THE MARYLAND-NATIONAL CAPITAL PARK AND PLANNING COMMISSION

PGCPB No. 07-161(A)

14741 Governor Oden Bowie Drive
Upper Marlboro, Maryland 20772
TTY: (301) 952-4366
www.mncppc.org/pgco
File No. DSP-99048/01

A M E N D E D R E S O L U T I O N

ALT 4 — 2 BEDROOM WITH DEN PLAN

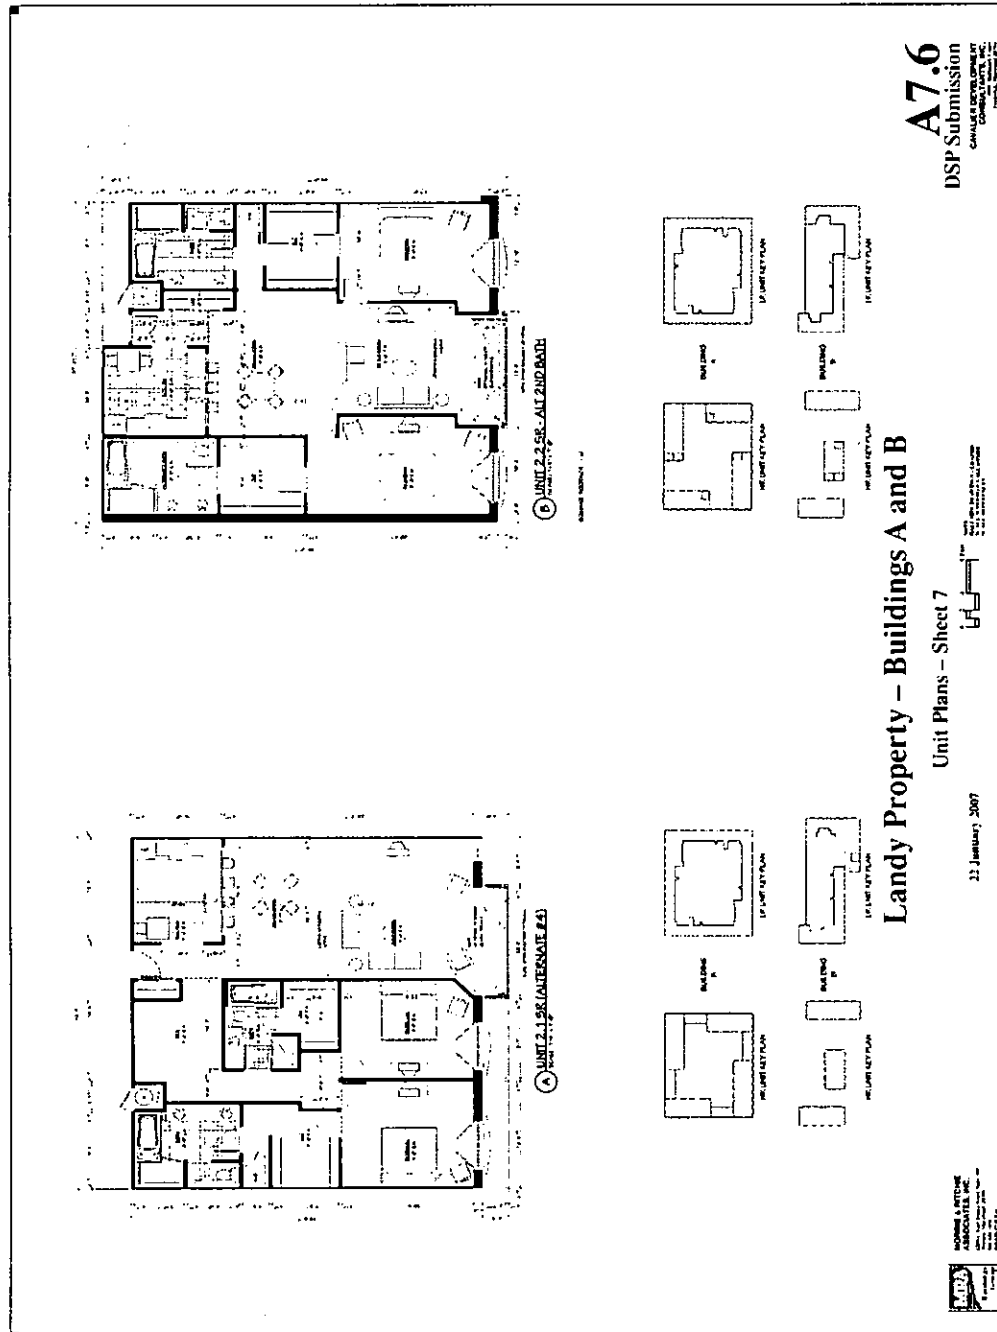
*[~~"§27-107.01(23). In this instance where the developer proposes large, luxury units, this definition of a "bedroom" is misplaced and a deterrent to providing the type of living space that a sophisticated renter or homeowner seeks. For in this instance, the definition of a "bedroom" has the potential affect of this application being reviewed as proposing three bedroom units because the unit design includes a "den." The "dens" in the proposed units would not be an enclosed room, but rather an open, but spacially defined room without a door "for common social activities of the occupant," much like the kitchen, dining room or other common use areas of the unit. Please see below typical 2- and 3- bedroom floor plans. [See Exhibit Alt 4—2 Bedroom with Den Plan and Unit Type 3.1 and 3.2—3 Bedrooms with Den.]~~

UNIT TYPE 3.1 AND 3.2 — 3 BEDROOM WITH DEN PLANS

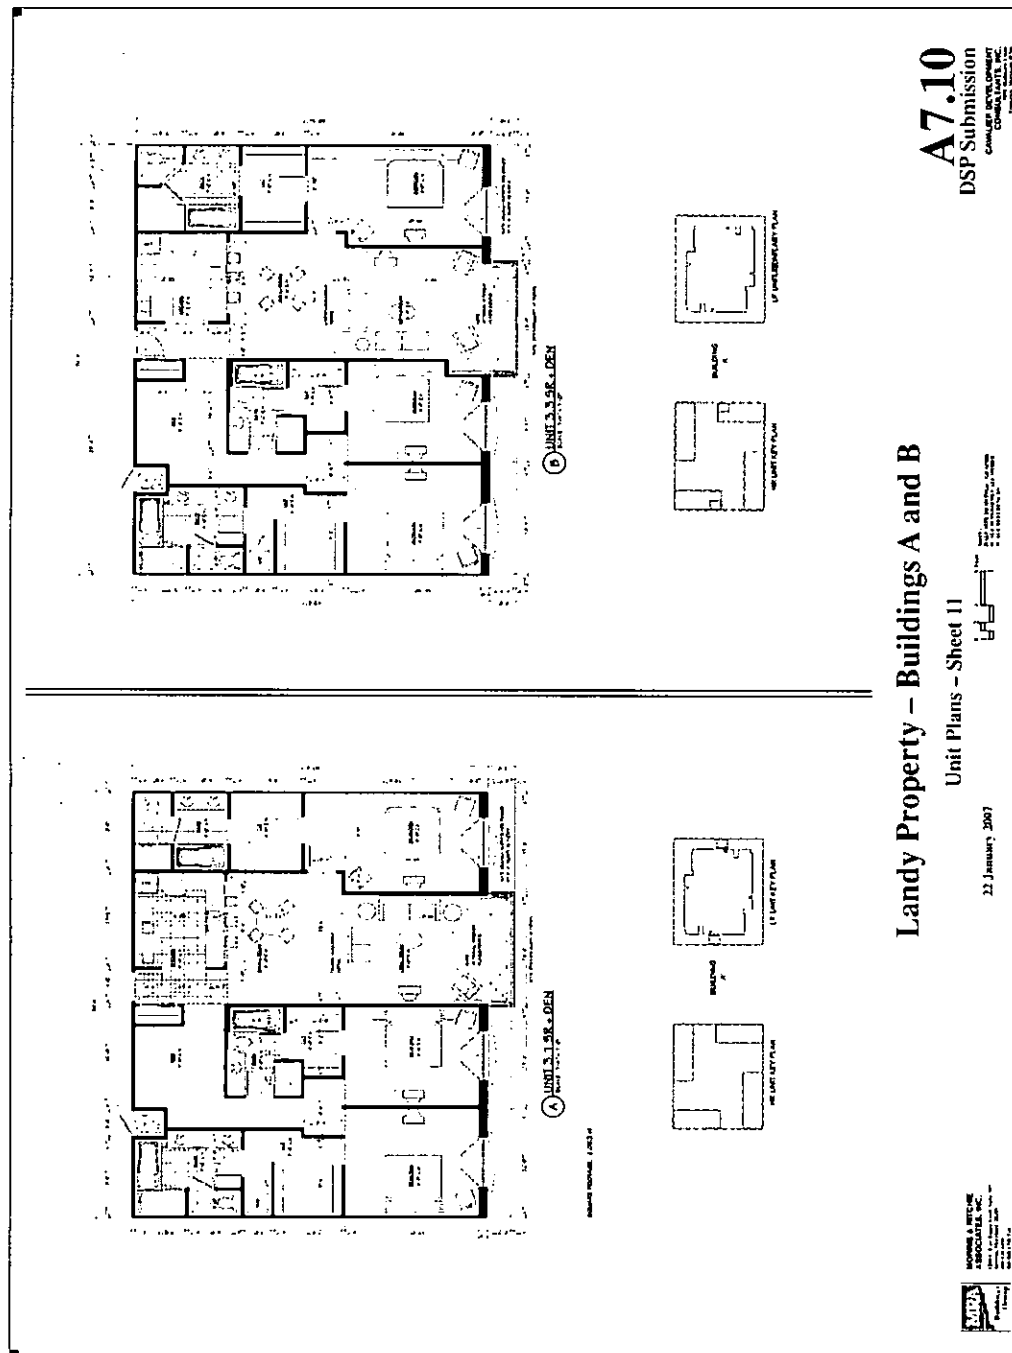
~~"Under the TDDP, three bedroom units are only permitted when the property is developed as a condominium. Here, with the likelihood of future condominium development, the three bedroom interpretation of the 'den' feature adds a particular twist because when the building converts to condominium this will no longer be contrary to the Design Standard. Thus, based on the potential that this property will convert to condominium, thereby obviating the need for an amendment at all, and the fact that the 'dens' proposed will in fact be dens in a luxury unit rather than a bedroom, we respectfully request a waiver from Design Standard P39 to the extent that staff determines that this plan does not comply with said standard."~~

FIGURE 1.

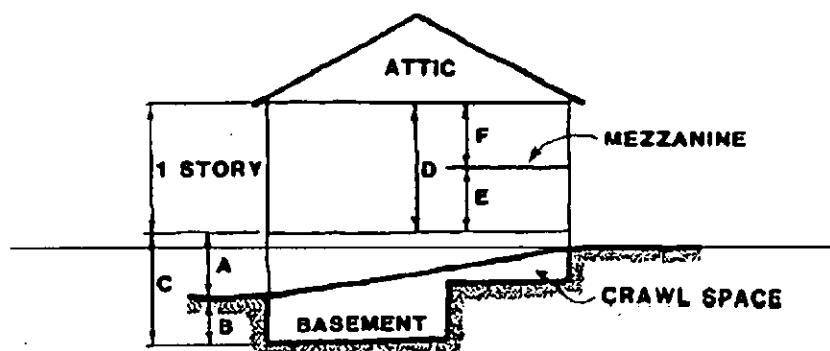
"Figure-1 of the Zoning Ordinance, as shown above, depicts a situation identical to what is proposed on the sixteenth story of the Landy towers. The main volume proposed is less than 20 ft high (at 18', 8"), and the proposed mezzanine floor area is never more than the required one third ($1/3$) of the contiguous, open floor areas to which it is open below. In addition, the 2003 International Building Code (the MD State Building Code) has a strict definition and set of requirements for mezzanines that is consistent with the $1/3$ area limitation stated in §27-107.01.(223) of the Prince George's County Zoning Ordinance. In IBC, mezzanines are not considered to be additional floor areas and exterior balconies have no occupancy load for egress purposes. The proposed unit design conforms to 2003 IBC requirements. The additional space proposed on the sixteenth story provides the units with striking, dramatic volumes and mezzanines that permit the owners the luxury of several options for utilizing the space."
